Access Compliance Report

Public Rights-of-Way

(Curb Ramps)

Intersection ID: 10040761	Main Street: W_TYVOLA_RD	Cross Street: N/A	Location: SE
ADA ID: D13369427668	Ramp Type: PerpDiag	Initial Pass/Fail: Fail	Overall Compliance: No
Severity Score: 58.75			
Codes/Mitigation Info/Possible Solution		Field Measurements/Component Compliance

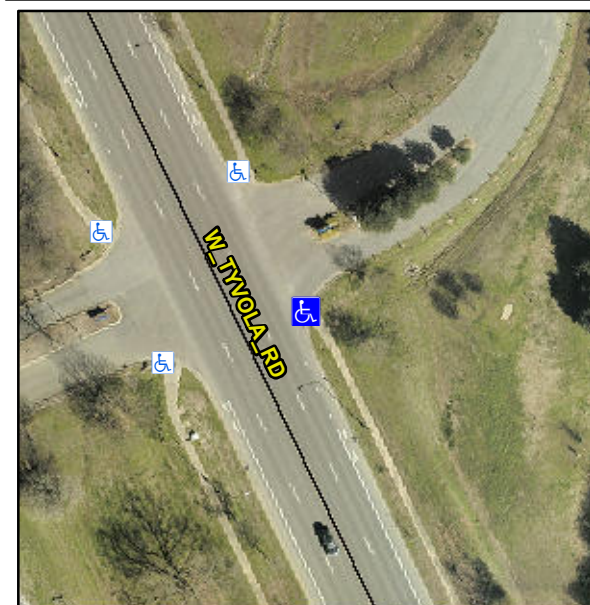
R304.5.1, R304.2.2, R304.5.3

Compliance	Description	Data	Compliance	Description	Data
N/A	Ramp Length (in)	68.0	No	Ramp Slope (%)	12.3
No	Ramp Width (in)	45.0	No	Ramp XSlope (%)	7.8
N/A	Flare Type LT	N/A	N/A	Flare Type RT	N/A
N/A	Flare Slope LT (%)	N/A	N/A	Flare Slope RT (%)	N/A
N/A	Flare Traversable LT?	N/A	N/A	Flare Traversable RT?	N/A
N/A	Landing Length (in)	N/A	N/A	DWS Provided?	N/A
N/A	Landing Width (in)	N/A	N/A	DWS Contrast?	N/A
N/A	Landing Slope (%)	N/A	N/A	DWS Length (in)	N/A
N/A	Landing X Slope (%)	N/A	N/A	DWS Full Width?	N/A
N/A	Landing Curb? (Y/N)	N/A	N/A	DWS Offset (in)	N/A
N/A	Shared Landing?	N/A			
N/A	Gutter Ponding?	N/A	N/A	Gutter Slope (%)	N/A
N/A	Gutter Lip Ht (in)	N/A	N/A	Gutter X Slope (%)	N/A
N/A	Painted X Walk1?	No	N/A	Painted X Walk2?	No
	X Walk 1 Direction	To N		X Walk 2 Direction	To W
N/A	X Walk 1 Width (in)	N/A	N/A	X Walk 2 Width (in)	N/A
	X Walk 1 Slope (%)	0.6		X Walk 2 Slope (%)	2.3
	X Walk 1 X Slope (%)	5.8		X Walk 2 X Slope (%)	0.6

Remove & Replace Curb Ramp With Two New Directional Ramps or Equivalent.
